SUBJECT: PHASE I REVIEW OF ACTIVITY 8.3.1.4.2.2.2 - SURFACE
FRACTURE-NETWORK STUDIES

SUBJECT: PHASE I REVIEW OF ACTIVITY 8.3.1.4.2.2.2 - SURFACE
FRACTURE-NETWORK STUDIES; INTERFERENCE CONCERNS
(411431 L64333)

Figure 2.2-1. Location of existing and proposed surface sites for fracture study at Yucca Mountain.

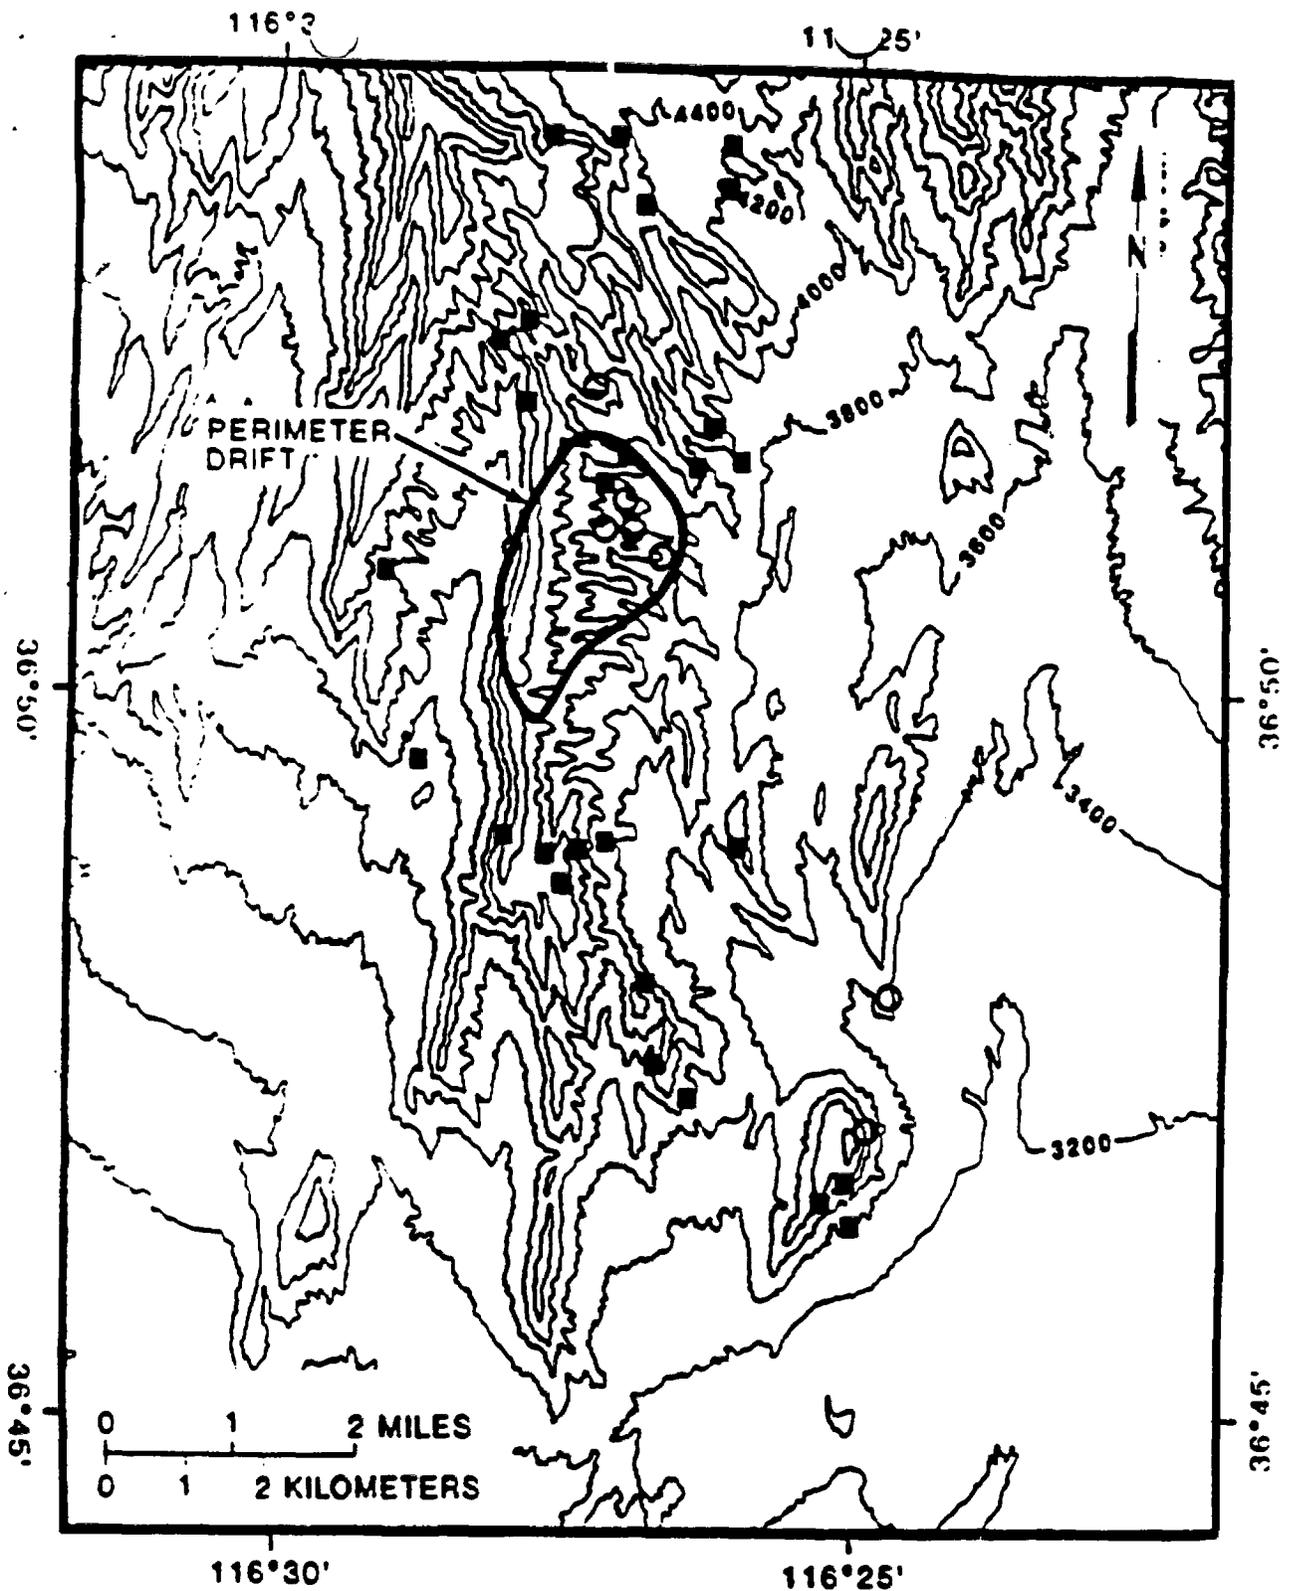
Generally, the concern relates to the use of water to clear pavement exposures for this activity. The activity plan indicates that analyses (SCP Section 8.4) have shown that the use of water to clear pavement exposures is not a waste isolation concern. The activity plan also states that a final evaluation of the interference potential of this activity is not currently possible because test locations have not been firmly established. In order for the Geology-Geophysics Section to complete its Phase I review, we need to know if the HT Section agrees with the assessment that these activities will have no impact on waste isolation. We also need to know if the lack of firmly established test locations and resultant lack of an assessment of the possible interference with other (hydrologic) tests constitutes a concern serious enough to warrant NRC staff action.

Keith has attached pertinent sections of the activity plan to this note. The PPSAS # and TAC # are 411431, L64333. We request that members of your section look over the planned tests related to this activity and assess whether the test methods do constitute either a waste isolation concern or test interference concern.

In response to the May 17, 1990, request of Keith McConnell and King Stablein to determine if the planned tests constitute either a waste isolation concern or a test interference concern, I have completed a review of pertinent sections of Activity Plan 8.3.1.4.2.2.2. No quantitative calculations were done for this review and the conclusions are based on my professional opinion. It is my professional opinion that the use of water to clear pavement surfaces as described in this study plan will not compromise the repository or result in significant test interference. This conclusion is based on Figure 2.2-1 "Location of existing and proposed surface sites for fracture study at Yucca Mt." This figure (attached) indicates that only 2 proposed sites will be located inside the site boundary and the rest will be widely dispersed; allowing ample area to conduct other types of tests in and around the repository block. It is felt that the amount of water used in these tests will not compromise the repository and that there will be ample areas unaffected by these tests to conduct other experiments.
